**ADDENDUM NO. 2**

**WINDOW REPAIR AND REPLACEMENTS FOR ST. CLAIR COUNTY SCHOOLS  
PACKAGE 1: RAGLAND HIGH SCHOOL, SPRINGVILLE MIDDLE SCHOOL,  
SPRINGVILLE HIGH SCHOOL**

Architect Job No. LAA-26-051-01

**1** SPRINGVILLE MIDDLE SCHOOL - AREA "A" UPPER LEVEL FLOOR PLAN  
SCALE: 1/8" = 1'-0"

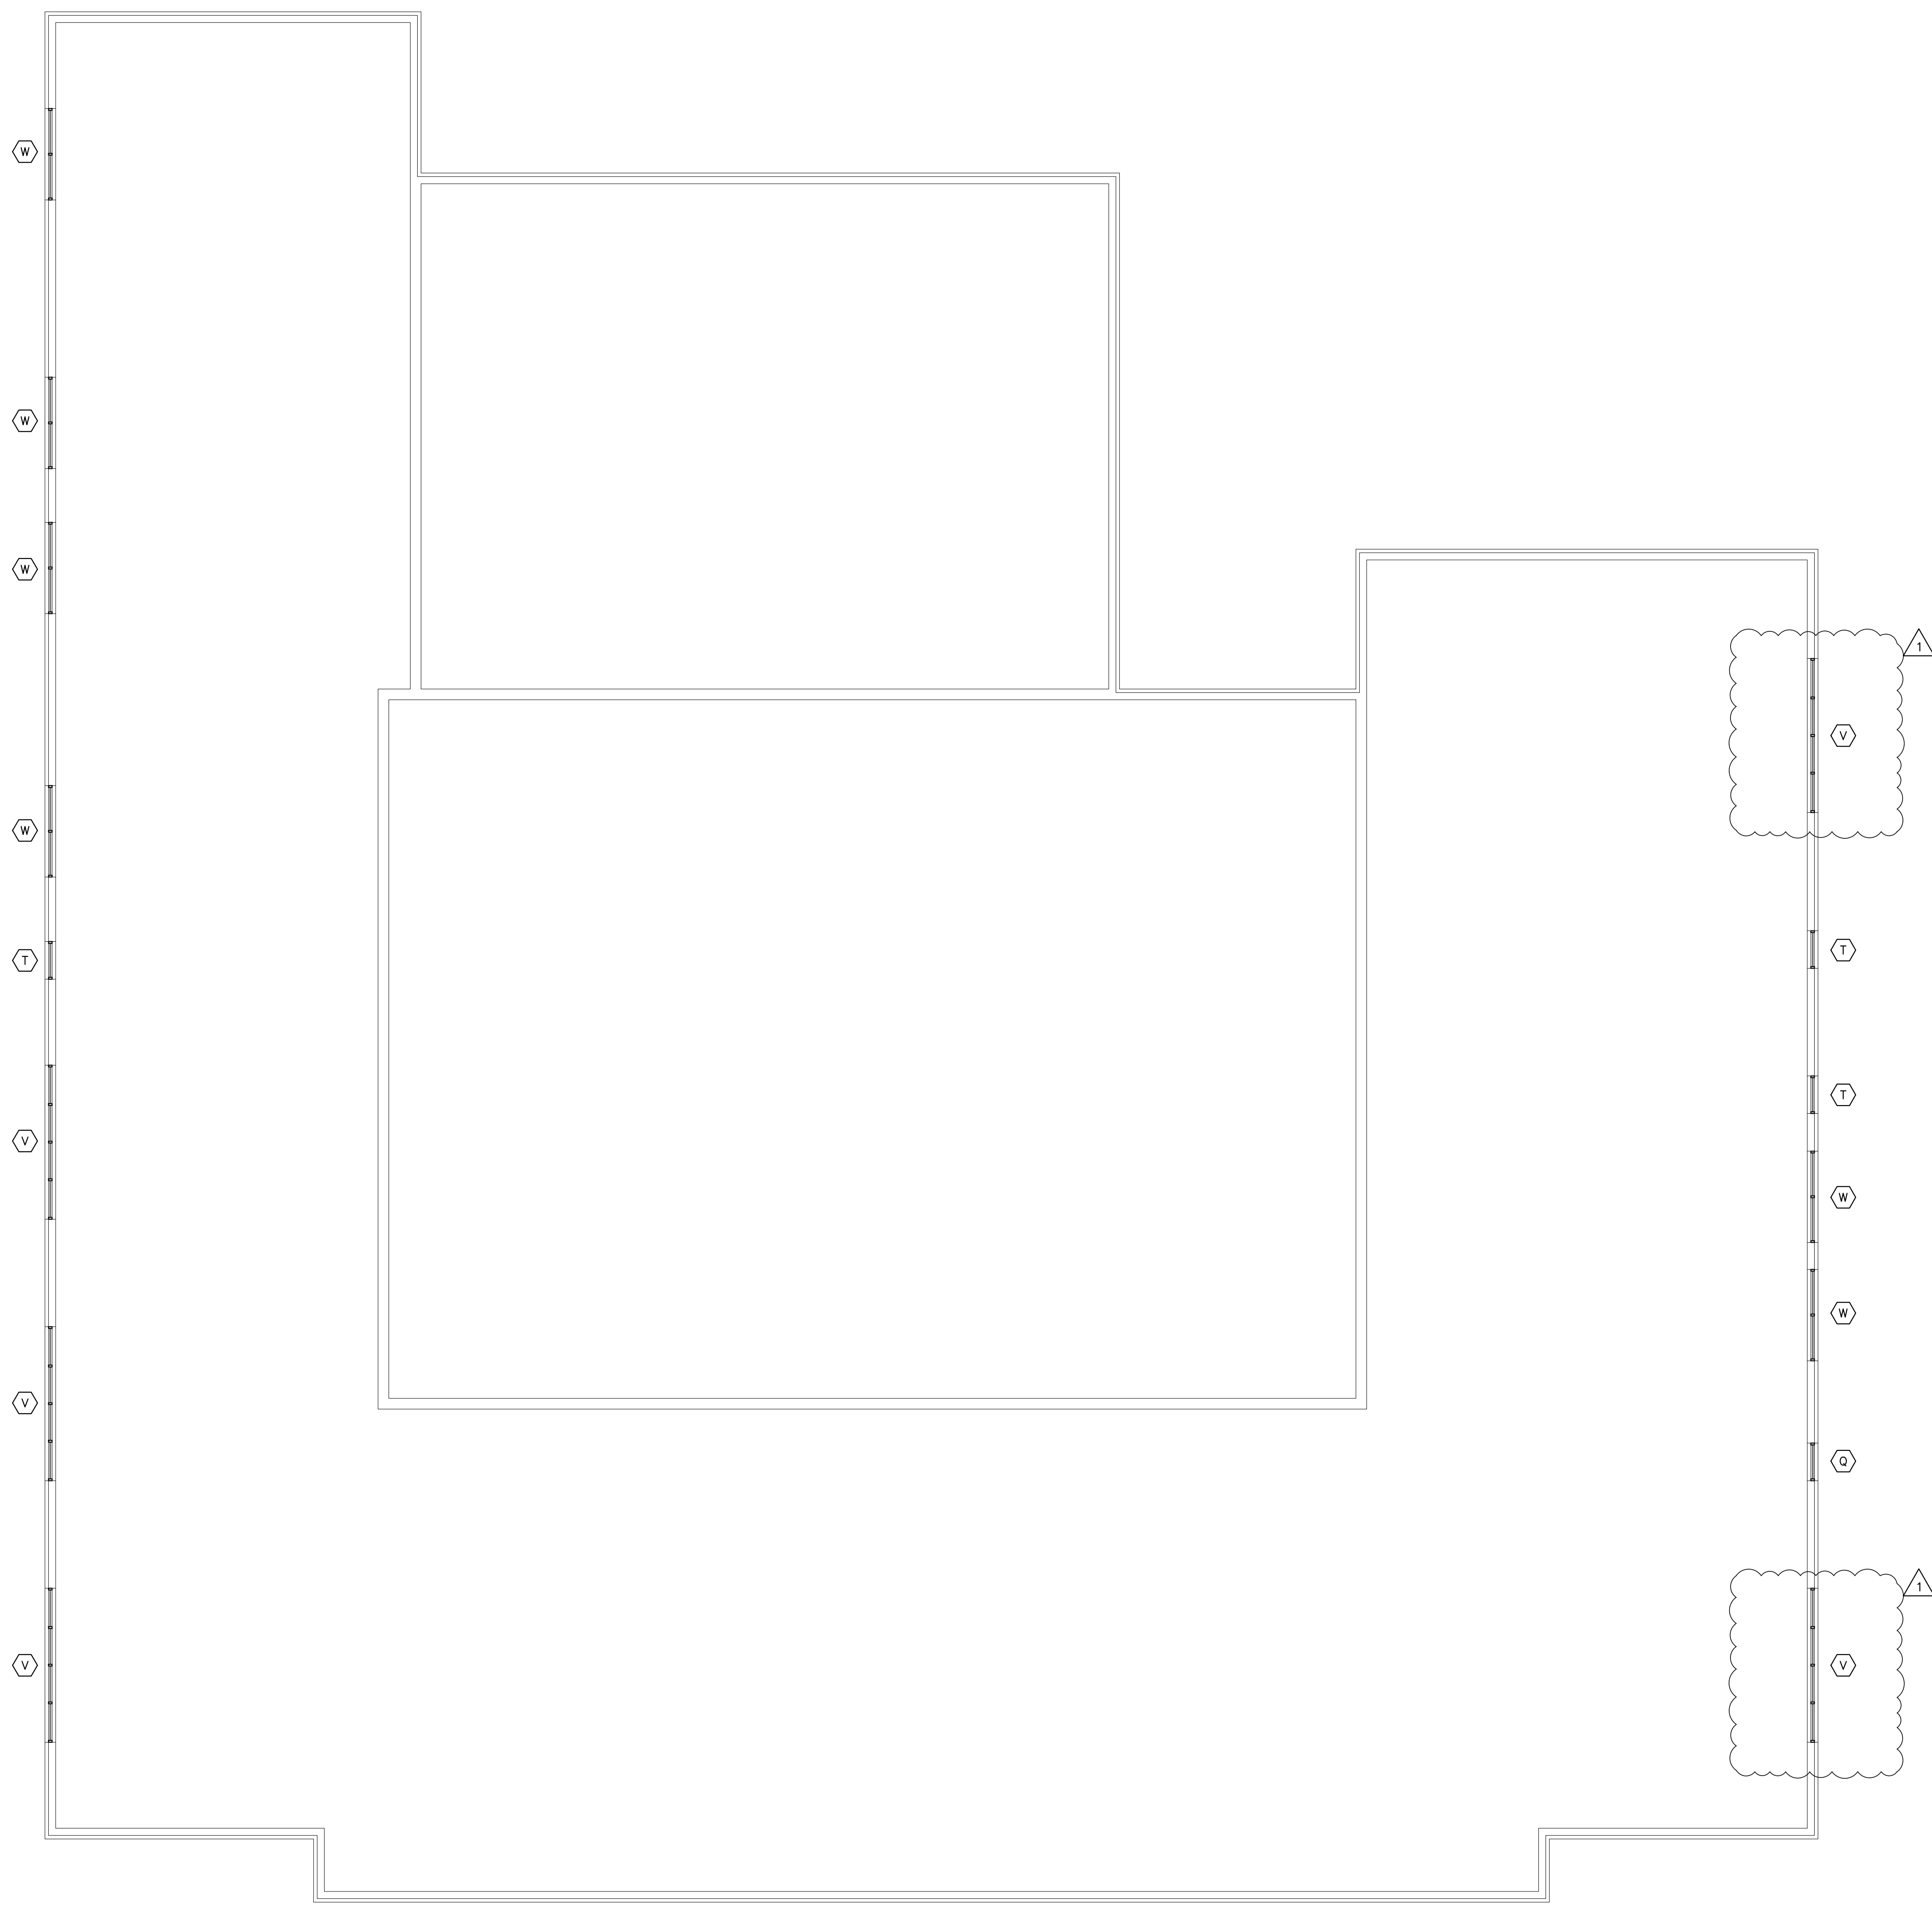
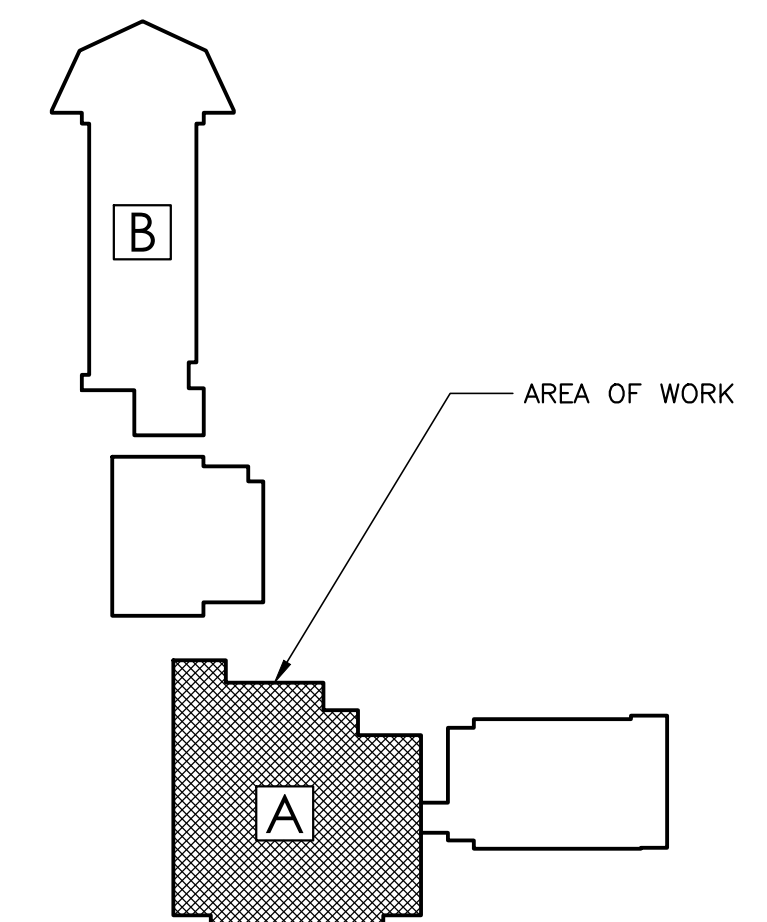
1. **A2.6 SPRINGVILLE MIDDLE SCHOOL AREA “A” UPPER LEVEL FLOOR PLAN**
  - a. CHANGED TWO WINDOWS TO TYPE “V” ON EASTERN ELEVATION AS INDICATED.
2. **A4.2 RAGLAND HIGH SCHOOL AREA “B” MAIN LEVEL PLAN**
  - a. AT DEMOLITION PLAN ADD DEMO NOTE #2 TO THE MECHANICAL UNITS.
3. **A4.5 RAGLAND HIGH SCHOOL AREA “B” UPPER LEVEL PLAN**
  - a. CHANGED FOUR WINDOWS TO TYPE “H” ON WESTERN ELEVATION AS INDICATED.
